Project #: 15630.00

Re: Response to Peer Review Letter #1 – Traffic Review
NOVO Riverside Commons
292-294 Baker Avenue
Concord, Massachusetts

VHB has received and reviewed the comments outlined in the November 6, 2023 Traffic Peer Review Letter from GPI on the proposed NOVO Riverside Commons development at 292-294 Baker Avenue in Concord, Massachusetts. The comments and our responses are provided below.

LAYOUT AND MATERIALS SITE PLAN

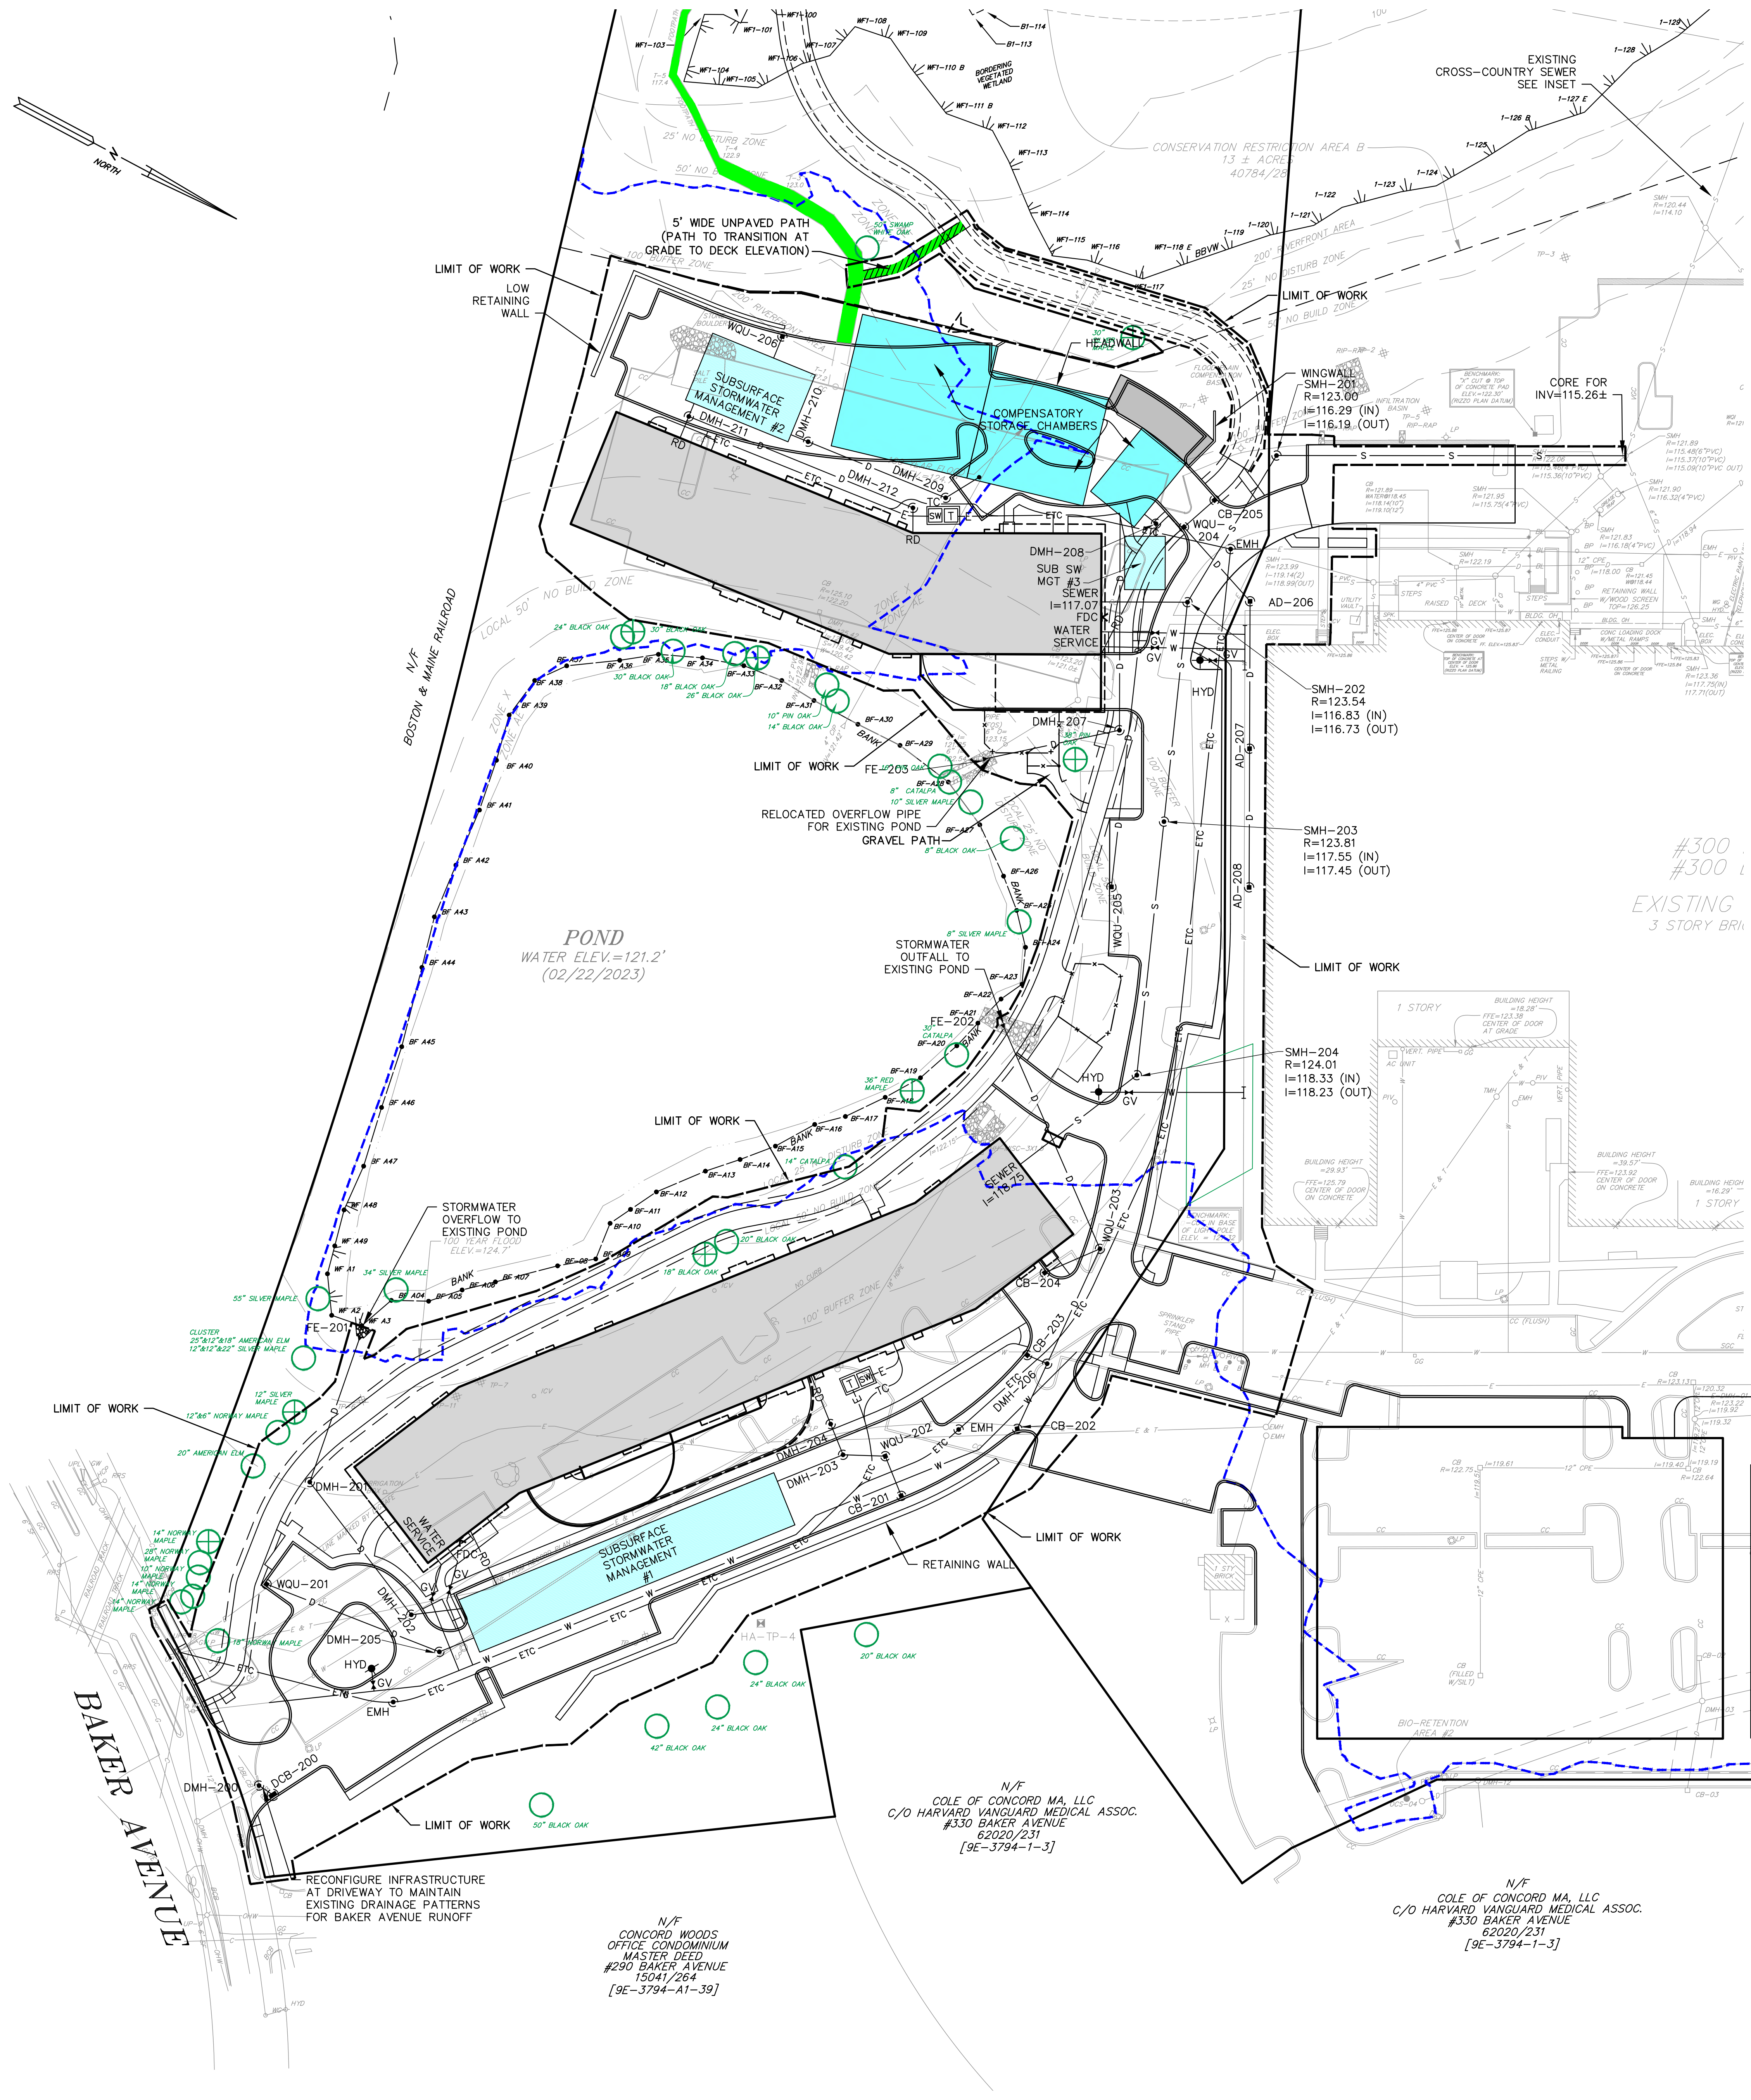
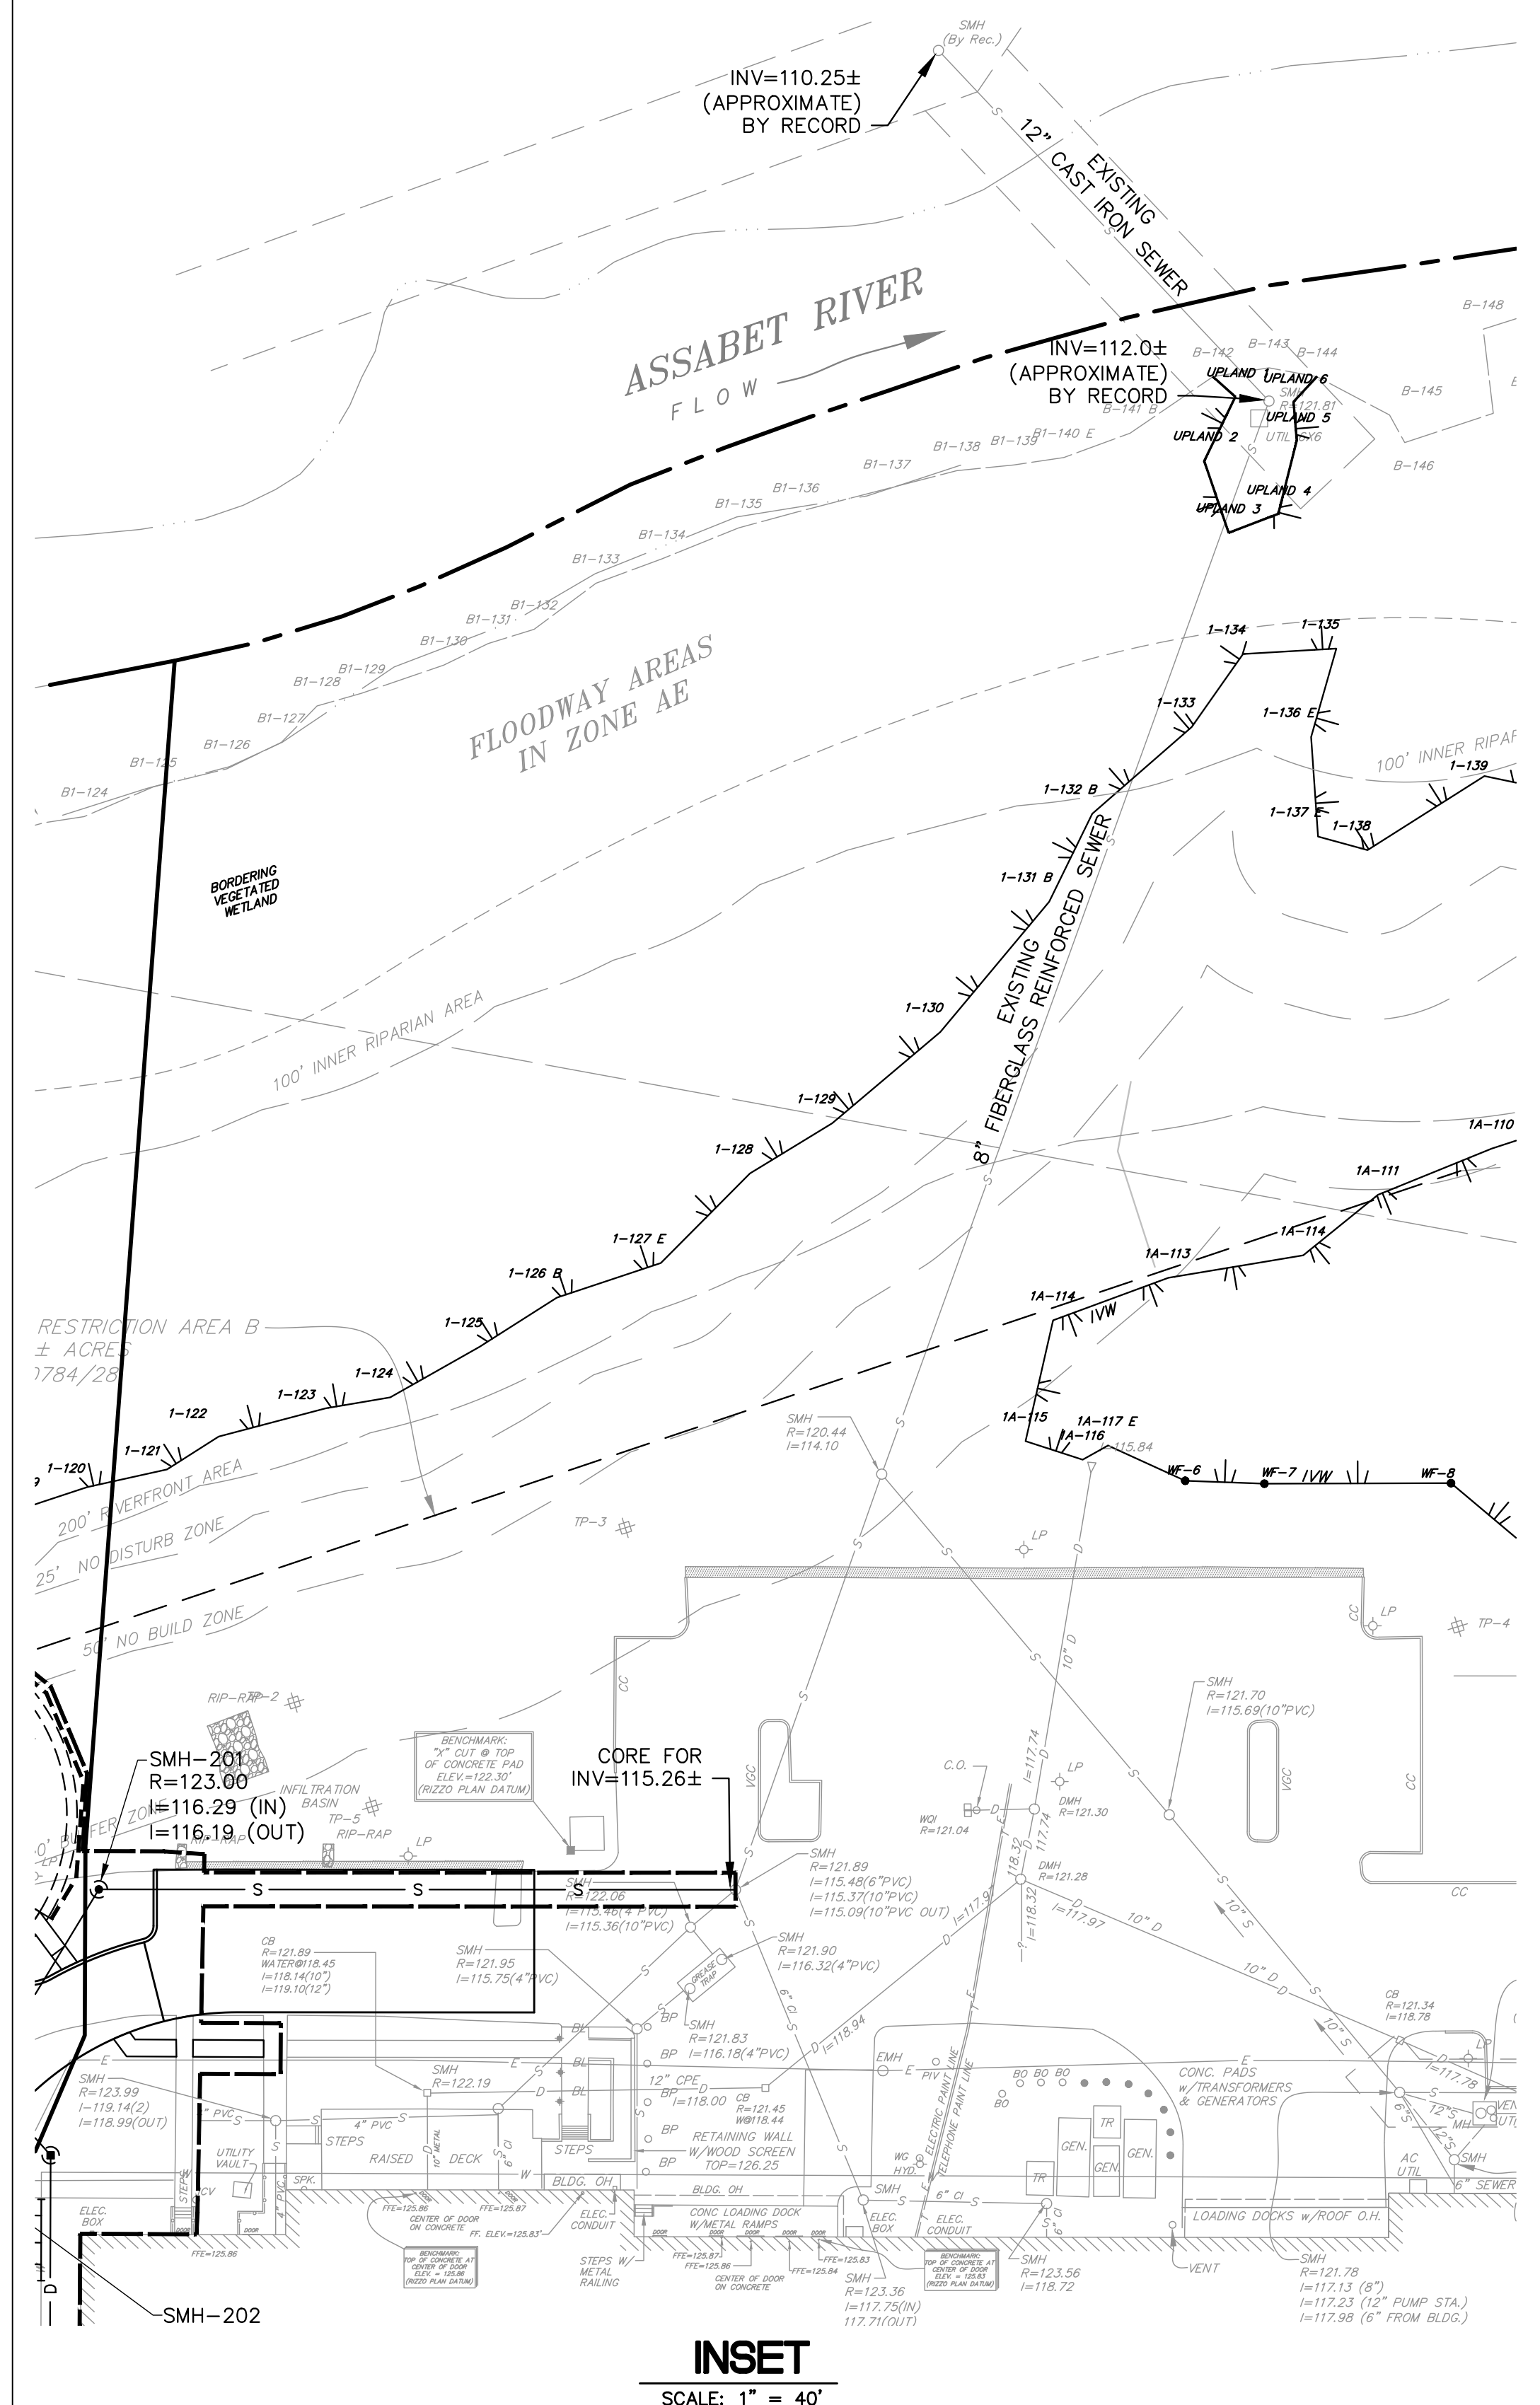
1. **GPI recommends that the Applicant install STOP signs and STOP lines for traffic exiting the site driveway onto Baker Avenue, as well as centerline markings on the site driveway between Baker Avenue and the entrance to the drop-off area at #292 Baker Avenue.**

2. **GPI recommends the Applicant install one-way arrows and signage, as well as STOP lines on the drop-off area exits at both #292 and #294 Baker Avenue.**

3. **There is currently no traffic control proposed at the internal intersection of the main drive aisle and the connection to #300 Baker Avenue. GPI recommends installing a STOP sign and STOP line on the #300 Baker Avenue driveway approach.**

ends at this internal intersection and no crosswalks are provided across the #300 Baker Avenue approach to this internal intersection. **GPI recommends the Applicant consider extending the sidewalks to provide a more continuous pedestrian path through the site, connecting to the parking field just west of the fire lane. In addition, the Applicant should consider installing crosswalks on all approaches to the internal intersection. Consideration should be given to the implementation of traffic calming measures, such as a raised or texture intersection.**

5. The main drive-aisle through the site is proposed to be 24-feet wide with perpendicular parking on both sides of the roadway. There are no sidewalks or crosswalks proposed for people parking in the first 30 parking spaces on the east side of the driveway to access the building at #292 Baker Avenue. This area will experience the heaviest volume of traffic during the morning and afternoon when residents are traveling to/from and employees are traveling to/from the adjacent office development. The lack of pedestrian accommodations in this area is likely to result in pedestrians walking in the roadway between flowing traffic and backing vehicles exiting parked spaces, resulting in significant conflict in this area. **GPI recommends the Applicant consider elimination of the parking spaces closest to Baker Avenue and/or provision of safe pedestrian accommodations for residents walking to/from these spaces.**

Response: We agree with the recommendations and have updated the site plans to reflect the stop signs and lines as well as centerline pavement markings. See attached.

Response: We agree with the recommendations and have incorporated the one-way arrows and signage at the drop off areas.

Response: We agree with the recommendation and have incorporated the stop sign and lines into the updated site plans.

Response: Beals and Thomas has updated the Site Plan to extend the sidewalk west of the Fire Lane to parking spaces on the north side of the drive aisle. We have also added a sidewalk from the sidewalk along the front of the 300 Baker Avenue building to the sidewalk that connects to the proposed sidewalk in front of the 292 Baker Avenue building via a crosswalk.

Response: We have added a crosswalk in the site driveway near Baker Avenue near the 292 Baker Avenue drop off area to access parking spaces on the east side of the driveway. We have also added a sidewalk along the ten parking spaces closest to Baker Avenue on the east side of the driveway.
